HCSA sheet RE-AB (2 Nov 2026, PROPOSAL): main rib option A against option B, section through the main rib at mid-span with the panes seated

Option B, thin: main rib I 400 × 100 × 25, web 8 (P-04, P-04A)
yields first at 1.96 atm as the hexagon main rib; the seams stay shut to ultimate, no leak-before-break window

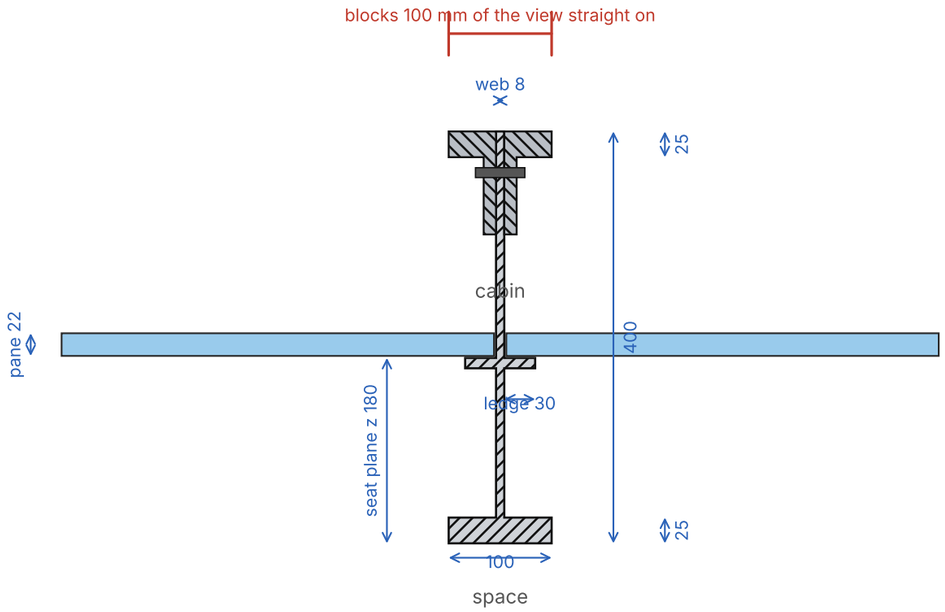
Drawn by sheet_AB.py from the parts library (CadQuery parts P-04, P-04A, P-10, P-10A). Not to scale between the two sections' text; the geometry is to scale. Question for Marco Cross and Rick Fleeter: do we keep leak before break (A) or take the view (B)?
